Re: Concept Engineering Report – West Treatment Pond
Virginia Pollutant Discharge Elimination System (VPDES) Permit No. VA0004138
Dominion – Bremo Power Station

SUBJECT: Concept Engineering Report
West Treatment Pond
Dominion – Bremo Power Station, VPDES Permit No. VA0004138

RE: Dominion Brema Power Station VPDES Permit No. VA0004138:
Revised Concept Engineering Report for the West Treatment Pond

**Concept Engineering Report:
West Treatment Pond**

**WEST TREATMENT POND
 MODIFICATION PLAN**

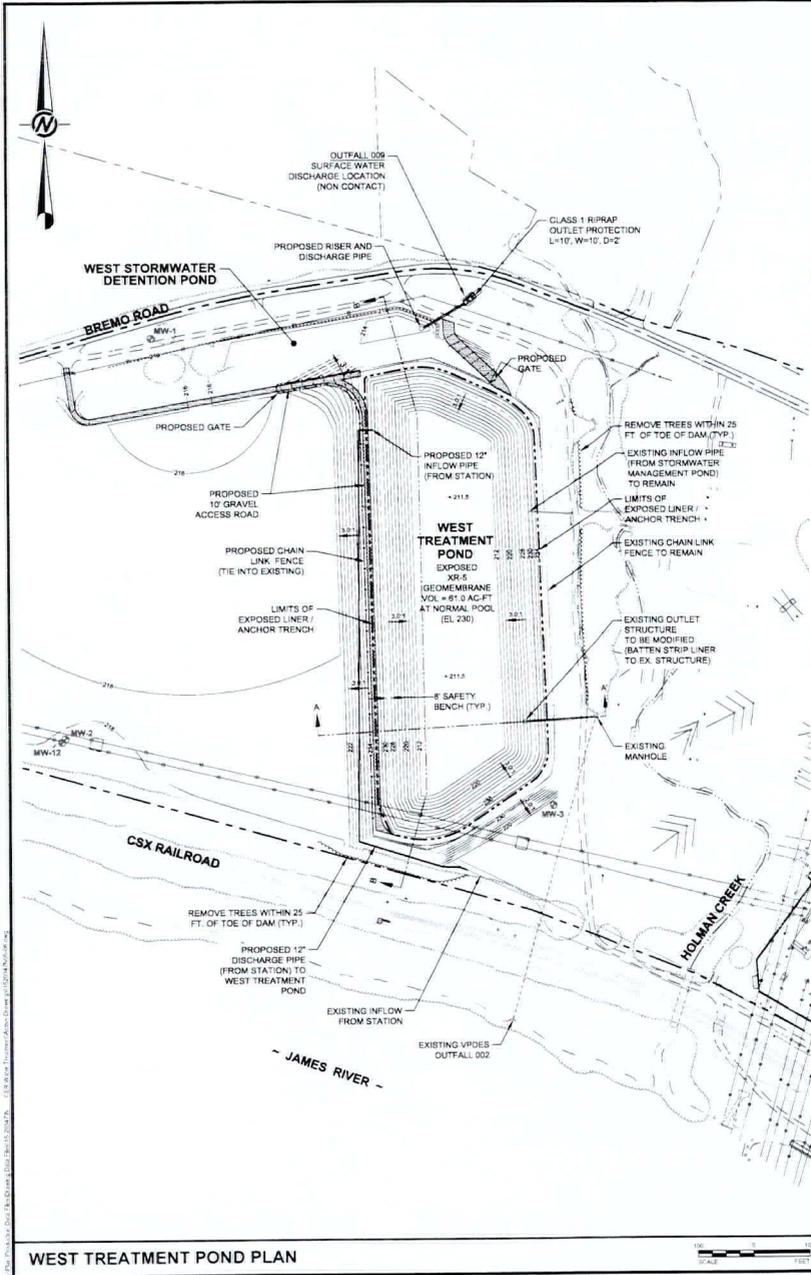
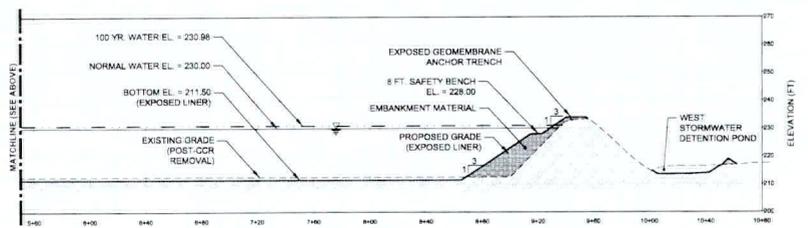
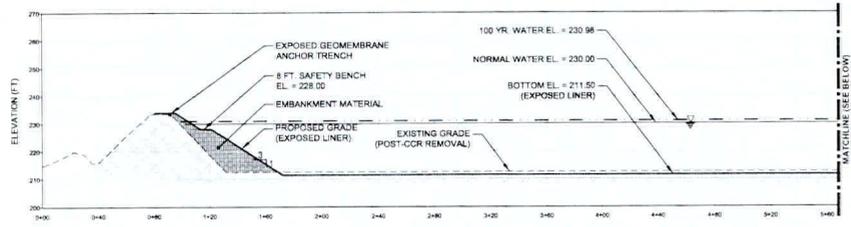
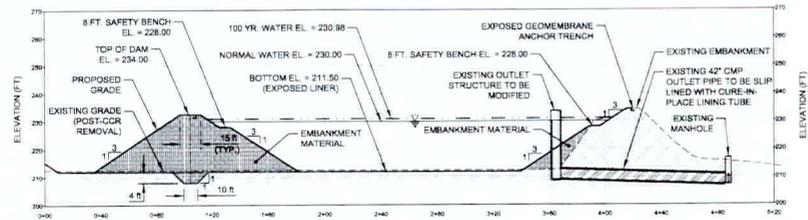
1. Updated the revision month and revision number
2. Added Appendix A (XR-5 Geomembrane Specification)
3. Section 2.1 - changed "sources are expected to be routed" to "sources may be routed"
4. Section 2.1.7 - changed "Stormwater Treatment Pond" to "Stormwater Management Pond"
5. Section 3.0 - specified the CCR being removed as "from the West Ash Pond, in accordance with the Virginia Solid Waste Management Regulations (VSWMR)"
6. Section 3.0 - removed the last two sentences of the first paragraph starting with "Construction of the West Treatment Pond will involve..."
7. Revised Drawing 2 to correctly label outfalls 004 and 003 and changed the drawing title from "Existing Site Map" to "Existing Outfall Location Map"
8. Revised Drawing 5 to label outfall 009 in the West Treatment Pond Plan
